# Response to Written Opinion of An Bord Pleanála ABP-309529-21

**Proposed Strategic Housing Development  
Clonminch/Gayfield, Tullamore, Co.Offaly**

Prepared on behalf of Steinfort Investments Fund

Figure 1: Sequenced release of masterplan lands in the Southern Environs

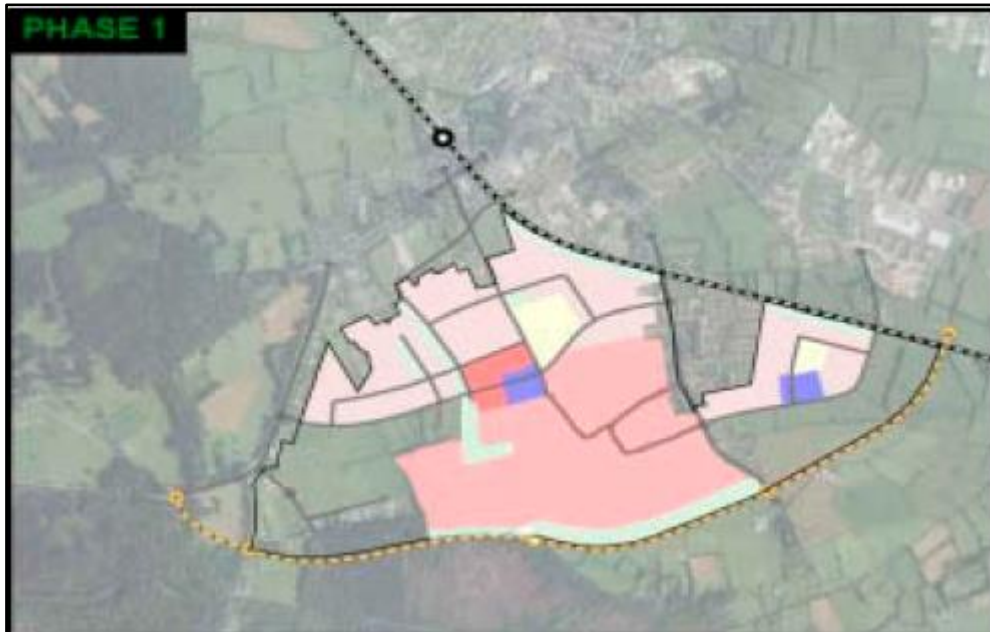
- i) *A clear rationale/justification for the release of the 'Third Phase' lands at this time having regard to the Core Strategy and Development Plan provisions regarding the phasing and release of masterplan lands.*
- ii) *In addition, a clear rationale/justification for the development of these lands in advance of other lands within identified nodes of the Southern Environs Masterplan, including the Spollenstown node, as set out in Table 5.5 of the Tullamore and Environs Development Plan, should be provided which considers the inter-dependency of each of the nodal areas identified and the suitability of the release of such lands at this stage.*

*Having regard to (i) and (ii) above, consideration should be given to Policy TTEP 04-01 of Variation No. 2 of the Tullamore and Environs Development Plan regarding the implementation of a sequential approach and further elaboration of how the release of these lands realises the aims of the core strategy, as set out in section 3.2 of Variation No. 2 to the Development Plan and consolidates the urban form at this location should be submitted.*

Both Table 5.2 and the Tullamore Southern Environs Phasing diagram (figure 1) show the northern portion of the Eastern Node to be ranked the same as Spollenstown Node – Phase 1/First Sequence. While the plan sought to develop Spollenstown first, chapter 5 states that flexibility must be provided to reflect market demands (para. 5.3). The Core Strategy outlines that in the control of development, the overall target for growth is an important factor in contributing to Tullamore achieving the necessary critical mass for a Gateway town and the planning authority will seek to deliver this population in a flexible manner using the principle of sequential approach (para. 3.5). The core strategy does not seek to create a monopoly whereby only one node may be developed to satisfy the growth within Tullamore.

Figure 6: Verified photomontages produced by Park Hood showing interface with Clonminch Wood and development as proposed.

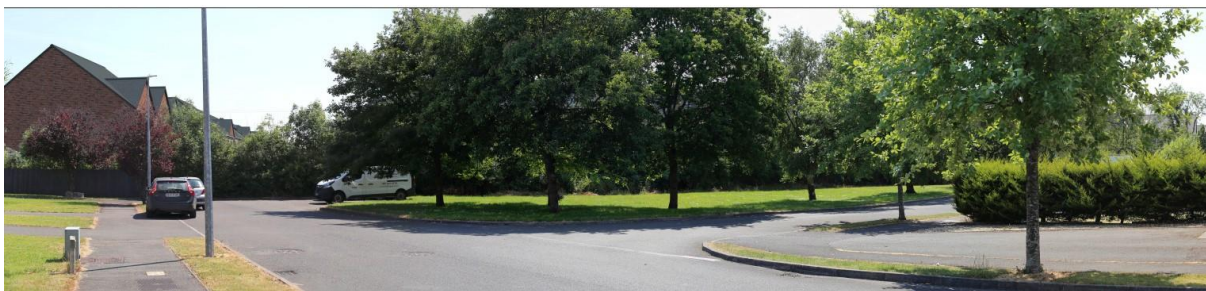
*Consideration should be given to how the layout creates active and aesthetically pleasing urban street frontages with a sense of enclosure and how the proposed elevational treatments respond to the site context creating focal points within the scheme. Consideration should also be given to the interface of the development site with the adjoining neighbourhood lands.*

***Cross sections, visualisations and CGI have been produced to illustrate the interface of the development with the adjoining neighbourhood lands. The preparation of a Nodal Masterplan ensures future development of the Node will integrate successfully with the development proposed.***

Figure 9: Extract from Park Hood Drawing No. 6473-L-304 – Block B

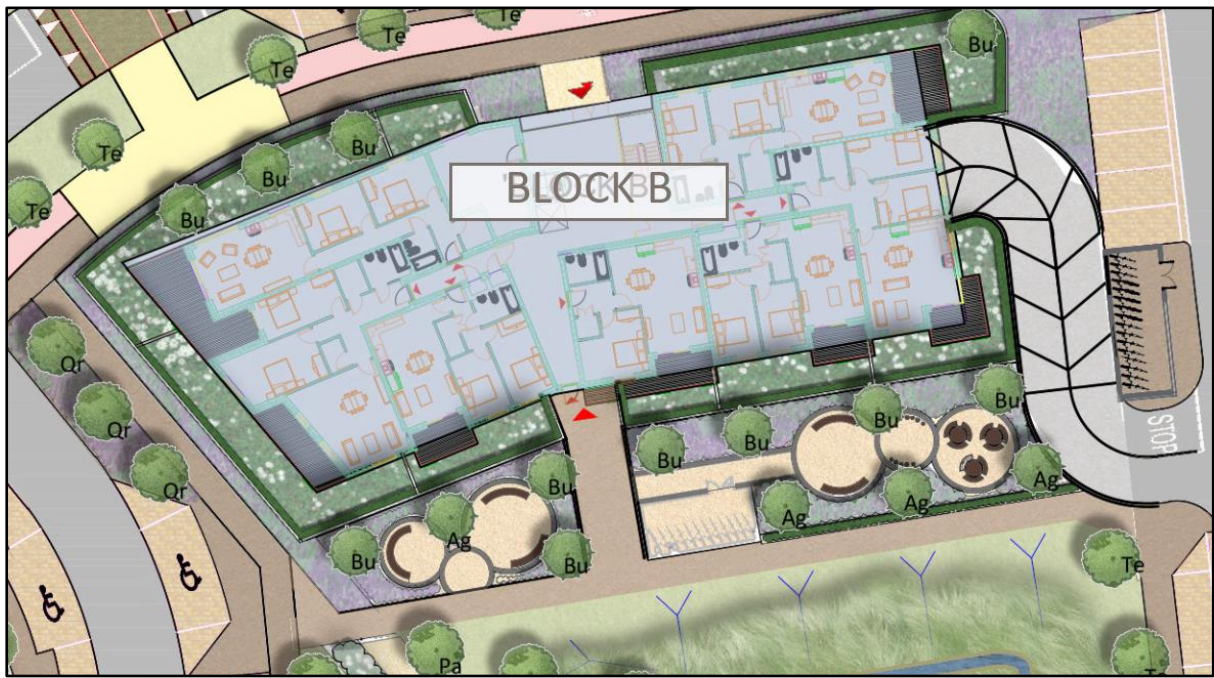
#### 3.3 RESPONSE OF APPLICANT 'A DETAILED LANDSCAPE PLAN FOR THE SITE WHICH CLEARLY DIFFERENTIATES BETWEEN AREAS OF PUBLIC, COMMUNAL AND PRIVATE OPEN SPACE, SURFACE FINISHES. CROSS SECTIONS, CGI AND VISUALISATIONS SHOULD BE PROVIDED'.

The Park Hood drawings that illustrate the site wide Landscape Proposal are prepared using a ground floor layout for apartment buildings proposed to clearly show the relationship private open space has to the interior layout of each unit. For example, Block B shown at figure 9 clearly differentiates between the ground floor private terraces separated by buffer planting and the communal open space area to the south featuring amenity seating and formal planting. The circulation space is kept to the outside of this area and distanced from the building to ensure residents privacy while views to Clonminch Square to the south can still be enjoyed.
